APPLICATION

SEWAGE DISPOSAL TESTING

HOWARD COUNTY HEALTH DEPARTMENT
ENVIRONMENTAL HEALTH SERVICES

SUBDIVISION Miller Property *part of it is Lot #4 per plat of 10/6/78 & contains approved pub area* LOT NO. Three *11-4-53*

Lot 3

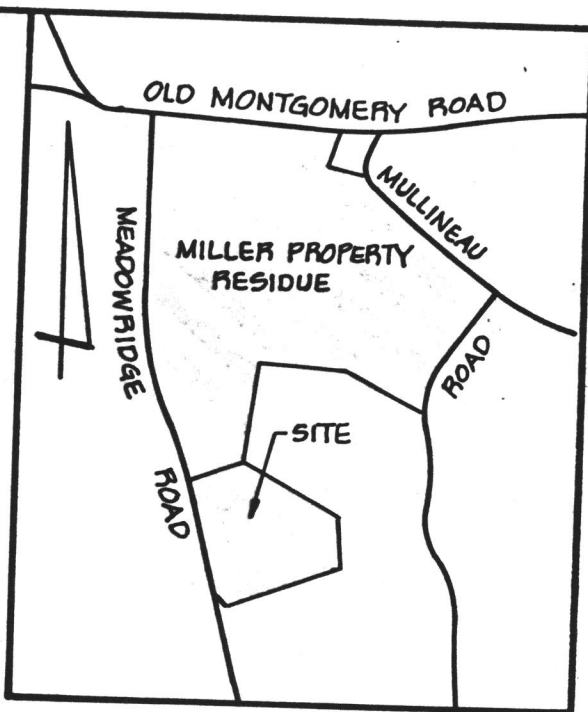
REASONS FOR REJECTION OR HOLDING 1/19/78 PERC OK FOR TILE FIELD

HOLD FOR CERTIFIED HOLES & VISUAL HOLES ON RESIDUE LOT SEE LOT 2 FOR INSPECTION OF RESIDUE LOT R14. 2/7/78 FINAL PLAT OK R14

REMARKS DANGER OF CAVE IN BOTTOMS NOT TESTED
 RECOMMEND TILE FIELDS BETWEEN HOLES 1 & 2
 TYPE OF SOIL _____

Paul
DRAIN FIELD - 120 SQ FT BOTTOM AREA
DRAIN FIELD TUBE 3-4 FT DEEP FILLED WITH 1 1/2 FT STONE
START THE DRAIN FIELD AT A POINT 20 FT FROM
THE FRONT LOT LINE AND 110 FT FROM THE LEFT
SIDE OF THE LOT AS SEEN WHEN FACING THE LOT
FROM MEADOW RIDGE RD. RUN THE TILE FIELD
TOWARD THE BACK LOT LINE
TO THE COUNTY HEALTH OFFICER
ELLICOTT CITY, MARYLAND
